# CONTACT STIFFNESS vs. REALITY?? — HOW SHOULD STIFFNESS BE CHOSEN??

ASLB HEARINGS-Spring, 2002

**NUCLEAR REGULATORY COMMISSION**

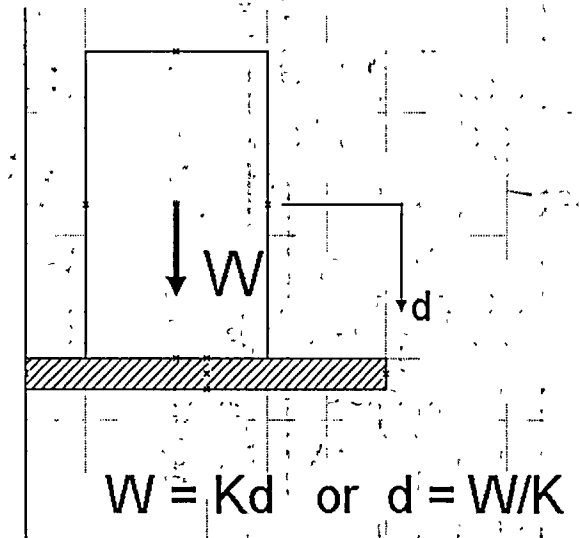
◆ **KAHN'S ASSUMPTION ->**

**$K = 1,000,000 \text{ lb/in}$  ;**

**$d = 360,000 / K = 0.36''$**

◆  $K = 10,000,000 \text{ lb/in}$ ;  $d = 0.036''$

◆  $K = 45,000,000 \text{ lb/in}$ ;  $d = 0.008''$

◆  $K = 454,000,000 \text{ lb/in}$ ;  $d = .00079''$
